# UNITED STATES PATENT AND TRADEMARK OFFICE

APPLICATION NO.	FILING DATE	FIRST NAMED INVENTOR	ATTORNEY DOCKET NO.	CONFIRMATION NO.
10/541,645	07/06/2005	Takeshi Honda	19002	4090
23389 7590 03/28/2007 SCULLY SCOTT MURPHY & PRESSER, PC 400 GARDEN CITY PLAZA SUITE 300 GARDEN CITY, NY 11530			EXAMINER LUU, PHO M	
			ART UNIT	PAPER NUMBER
			2824

**Office Action Summary**

### **DETAILED ACTION**

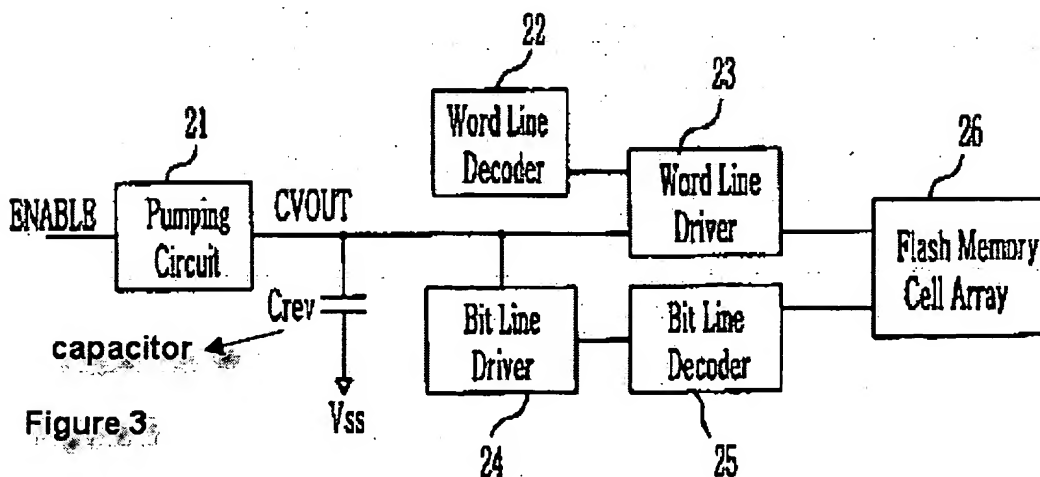
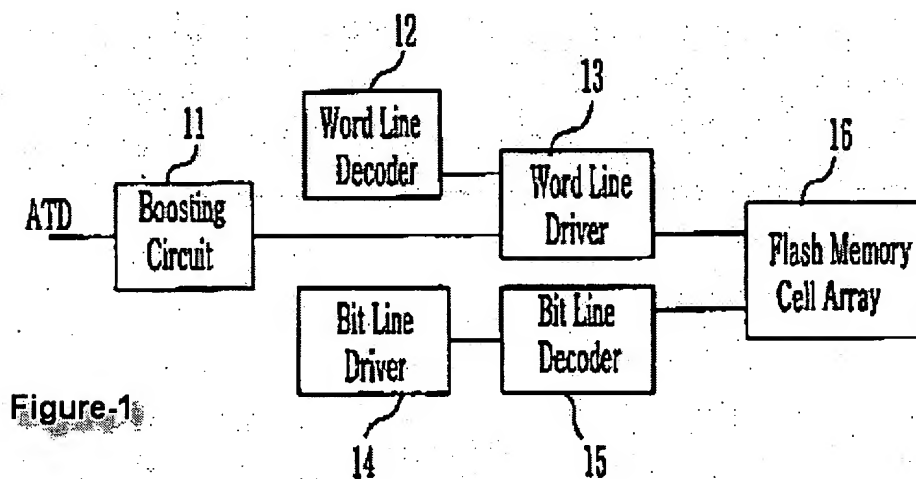
Regarding claim 1, Admission in Figure 18 discloses a semiconductor memory device (MRAM, paragraph 0002, line 5) comprising:

a constant current source (constant current source circuits 911, 912) for writing information into the storage element by flowing current (current flows ICX, ICY) for example, constant current source circuits 911, 912 provide a constant currents output ICX, ICY flow to memory cells through the capacitor CLX, CLY and X-DECODER, Y-DECODER, respectively) at a time when an amount of a current flowed (current flow ICX, ICY) by the constant current source reaches an amount of a current required to write information into the storage element at a predetermined position related to the storage element (for example, a constant current ICX, ICY

output from the constant current source 911, 912 flows in the array of memory cell through the capacitor CLX, CLY for select memory cell, paragraph 0016).

Admission does not disclose a boost circuit for charging parasitic capacitors at a time when an amount of a current flowed the constant current source reaches an amount of a current required to write information into the storage element at a predetermined position related to the storage element.
